SEPT.17.2007 DRB MEETING

This previous development scheme was presented to the design review board in three meetings (May 15, 2007, July 30, 2007 and Sept 17, 2007) by Collins Woerman. The following comments has been compiled from notes taken at previous design review board discussions on this project.

DRB RECOMMENDATIONS TO THE PLANNING COMMISSION

VIEW LOOKING NORTH ALONG PARK PROMNADE

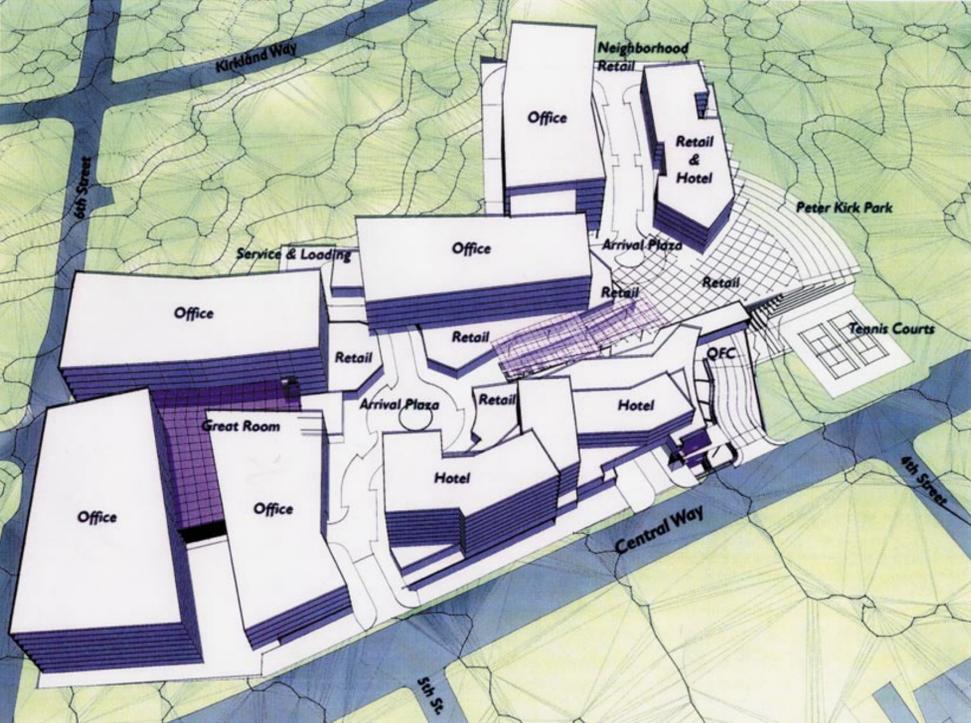
- The project is too massive. (Building height and floor plate size. Show the height to floor plate relationship for buildings.)
- Provide examples of similar project in scale / size for comparison.
- Provide variety in building massing / identity - No corporate campus
- Appropriate scale along all edges; especially on 6th Street and Central Way.

- Highlight connections to surrounding area; avoid island effect.
- Strengthen sidewalk fabric and connections through the site.
- Limit the number and proximity of driveways.
- Provide clear access route through the site.
- Streets should be slow moving along retail frontage.

- Need a more “organic design“
- Provide a sequence of outdoor spaces and scale throughout the site.
- The form of exterior spaces seems too urban; not enough real landscape
- Extra height should be large open space for people.
- Remove Peter Kirk Park landscape plan from the drawings unless plan to fund it.
- Complete sun and shadow analysis for public area.

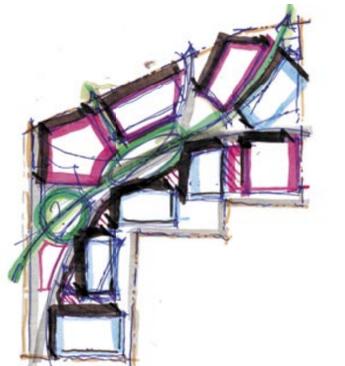
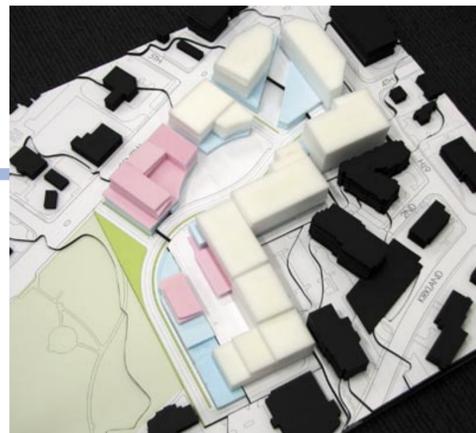
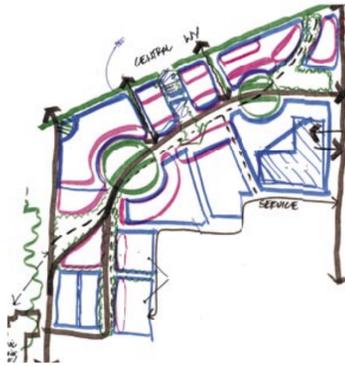
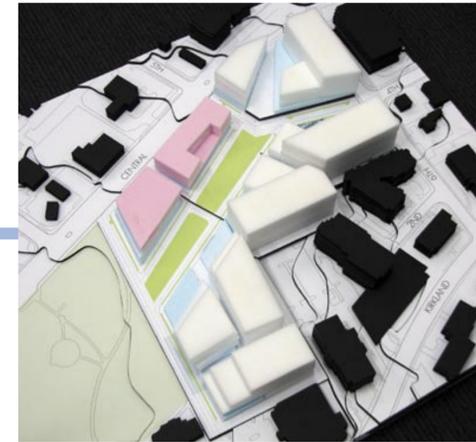
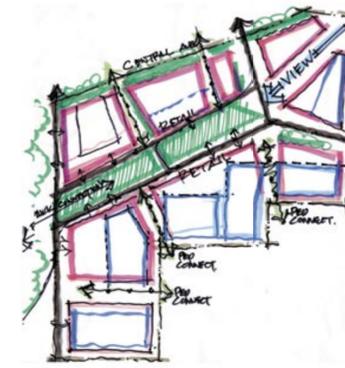
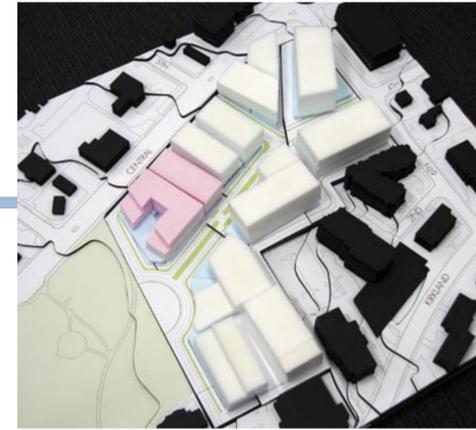
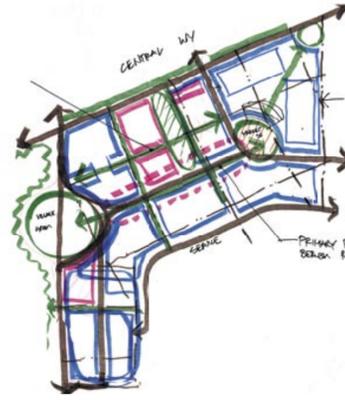
- How does the project link to other public spaces?
- Link central space to the park gateway. - What is proper approach?
- Would like to see more diagonal link to the park.
- The SE corner buildings are backing up to their neighbors on adjacent sites. - How to mitigate / address.
- Concerns about building heights.
- Concerns about street between park and project because main pedestrian traffic coming from the park will cross there. - How will traffic be calmed / mitigated.
- Liked slip street and how it works with Central Way.
- Want more information on public views. Develop view corridor studies.

JAN.07.2008 DRB MEETING

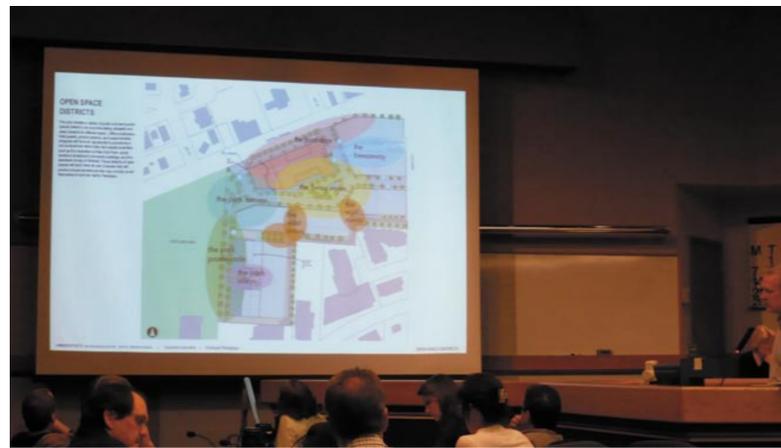
- Concern about the project scale / massing - too big?
- Ordering scheme of project needs to be more easily read.
- Public realm, should be key to project - provide more shape.

- Develop spaces / distance between buildings.
- Open space as trade-off for height - should the main open space be larger?
- Main open space should be more connected to Peter Kirk Park.

- Is it possible to view through the project to the park?
- Mixed feelings about the park street, continued concern about traffic calming and pedestrian crossing. However general understand by board street / retail impact at park edge.

- How will building heights to be measured.
- Floor plate sizes - diminish with height?
- Buildings massing all looks alike - provide more variation in massing and floor plate size.

- How should buildings be treated at corners? Step backs like Seattle?
- What is appropriate response to gateway at 6th and Central?
- Buildings should step back from park,

- More information was requested on slip street along Central; park set back; parking along park -one sided or two sided; size of living room - provide comparison studies; provide solar studies

1. SETBACKS

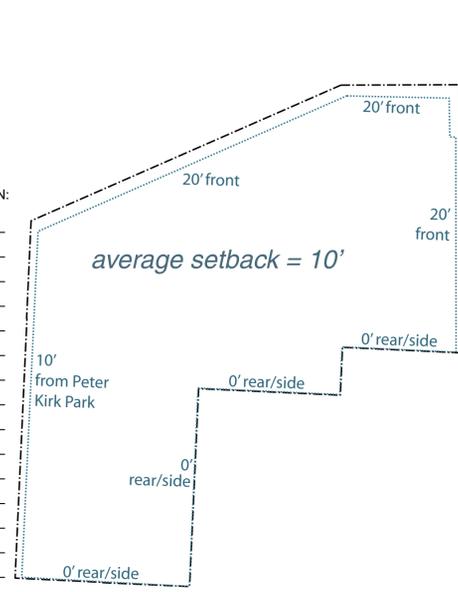
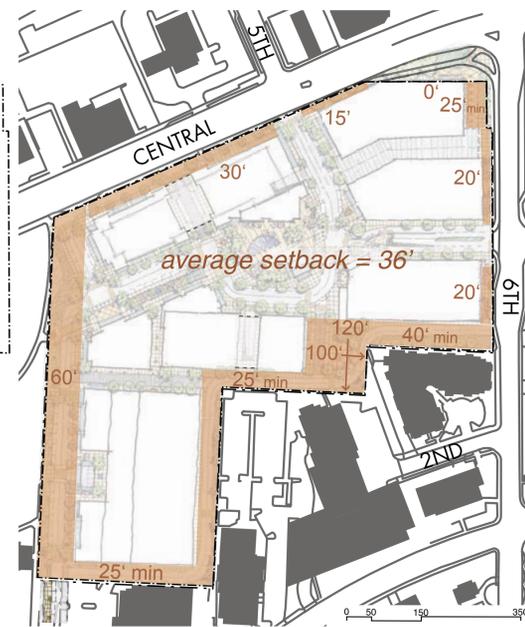
Based on the preliminary design concept, is it appropriate for the Kirkland Parkplace development to decrease front yard setbacks on:

- major pedestrian sidewalks, or pedestrian oriented streets

from 20' to 0' provided an overall average set back of at least 20' is achieved?

3. Setbacks: The setback should generally follow those which are shown on the current mixed-use plan. Buildings which anticipate street-front retail should back-up against the side walk. If retail cannot be achieved, then a great setback should be accommodated along pedestrian-oriented streets.

2. HEIGHT

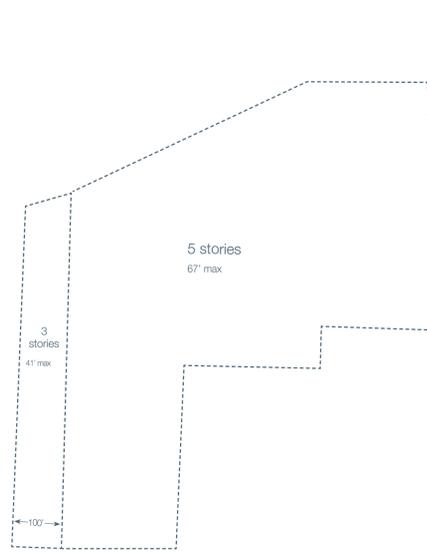
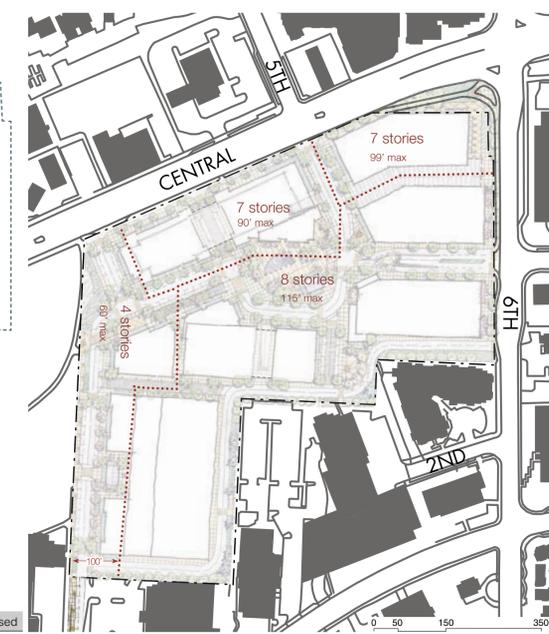
Based on the preliminary design concept, is it appropriate for the Kirkland Parkplace development to increase height from 3-5 stories to 4-8 stories in certain locations?

2. The site should have 3 height zones:

Height Zone A [Lowest Zone]: This zone should extend along Peter Kirk Park and along Central Way. The approximate height of this zone should be 45-50 feet [or approx. 3 stories]. The zone would be 100 feet wide along the park. Along Central Way any portion of the building above the 45-50 height would be required to 'step back' approximately 10-15 feet

Height Zone B [Medium Zone]: This zone runs along Central Way and along the west side of the site adjacent to the 100' setback along the park. The height of this zone would be approximately 75 feet [5 stories].

Height Zone C [High Zone]: This zone runs along the eastern and southeastern portion of the site. It abuts the major open space to the north and the medium height zone to the west. The approximate height of this zone would be approximately 115 feet [approx. 8 stories].

3. OPEN SPACE TO BUILDING FOOTPRINT

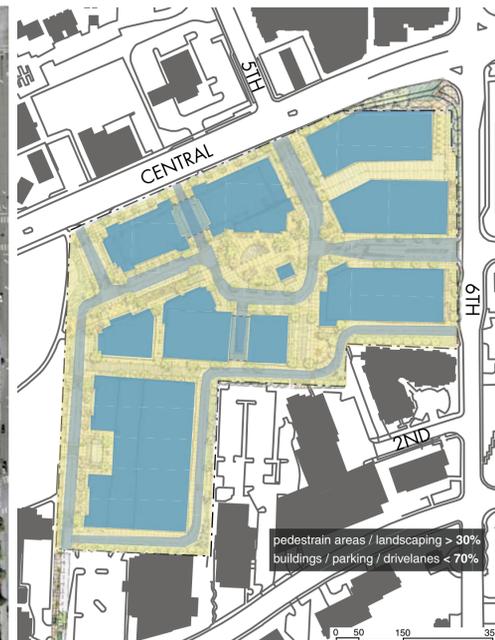
Based on the preliminary design concept, is it appropriate for the Kirkland Parkplace development to limit the building footprint and drive lanes to allow for a minimum of 25% open space (plazas, courtyards, pedestrian pathways, etc)?

4. Open Space: The current development plan provides an open space that seems distinct and separated from Peter Kirk Park. The discussion diagrams created by the DRB imply a continuous [150 feet?] major open space/ public green similar to one of the original armature concepts. The open space should be seen as an extension of the park into and through the Kirkland Park Place site. The discussion diagrams also indicate that the major Open Space be oriented such that it would continue the view created with the view corridor from the corner of 6th and Central Avenue.

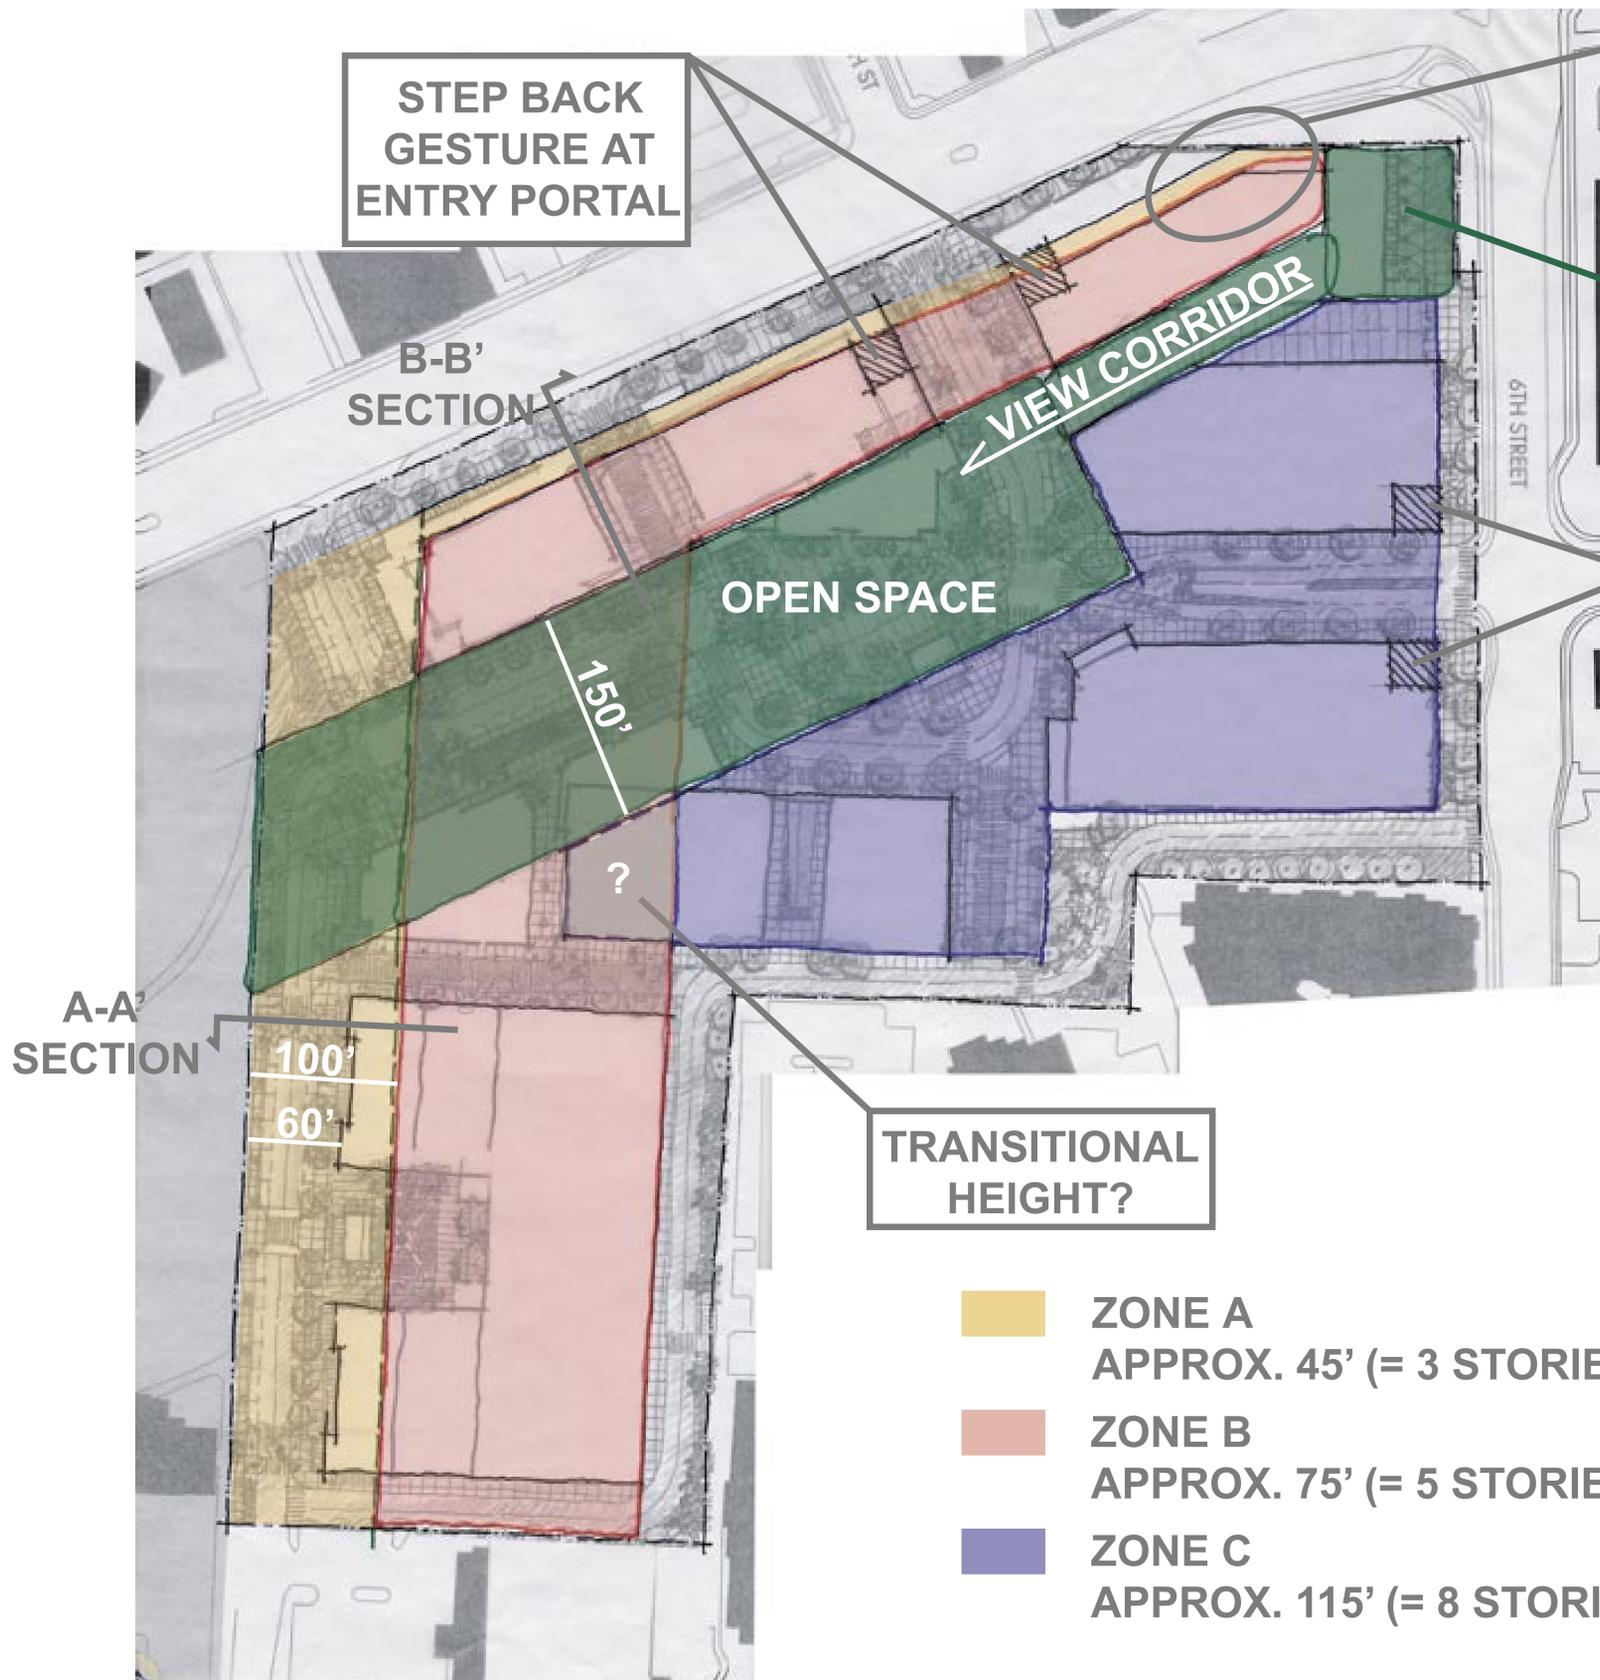
1. The Gateway at 6th and Central Way: View corridors should cut through site as seen from the corner of 6th and Central. Additionally, to frame the view down Central, a lower building should be provided adjacent to Central Way with significant setbacks and a 'subtractive approach' to the handling of the massing at the corner. The 6th and Central Building should not read as being 'paired' with the 8 story building/ winter garden directly to the south to avoid the perception of one large building. It was suggested that it be paired, or in the same grouping as the buildings along Central Way. The 6th and Central Corner building should have a significant [min 15-20 feet] of height differential from the building directly to the south.

Stepped Height from the park: In that portion of the medium height zone that abuts the 100 foot setback along Peter Kirk Park, buildings should step back 1 foot in width for every 1 foot in height.

1. Loss of approximately 120,000 sq. ft. of office space in building at the corner of 6th and Central Way.
2. Inefficient office floor plate in building at the corner of 6th and Central Way
3. Inefficient retail floor plate in building at 6th and Central Way
4. Loss of approximately 100,000 sq. ft. in office in the stepped building along the park.
5. Loss of 45,000 sq. ft of hotel space [meeting space would have to be pulled out of project in order to accommodate critical mass of rooms?]
6. Total retail sq. ft. now stands at less than 200,000 sq. ft. This is less than project critical mass
7. Open space at a continuous 150' width would be extremely difficult for retail functioning. Width of open space may be too wide for shoppers to traverse.
8. 1:1 Step back at Peter Kirk Park could be more stringent than current zoning.
